**Comments on the validation
Huadian Ningxia Lingwu Phase II 2×1000MW Ultra-Supercritical
Power Generation Project, China
4 May 2011**

CDM Watch respectfully submits the following comment on the Project Design Document (PDD) for “Huadian Ningxia Lingwu Phase II 2×1000MW Ultra-Supercritical Power Generation Project”, China. We highlight the importance of recognizing the integral role of transparency in the CDM validation process, and for taking this comment into consideration.

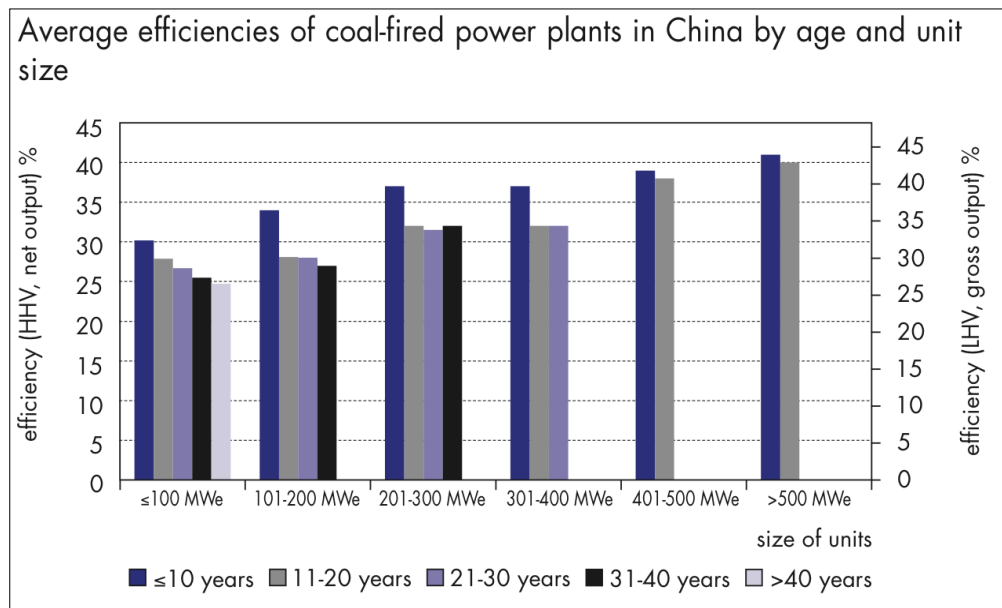
The figure below from IEA (2008b, page 51) illustrates the efficiency improvements achieved in coal fired power plants in China. The figure shows that power plants between 100 and 400 MW, constructed in the last 10 years are 5-6% more efficient than power plants constructed in the ten years previously. This results in efficiency gains of 0.5% to 0.6% per year for power plants built in the most recent decade. The figure also shows that the improvements vary with the size of power plants and over time.

Against the above said, project developers must show how the project takes into account the baseline efficiency improvement.
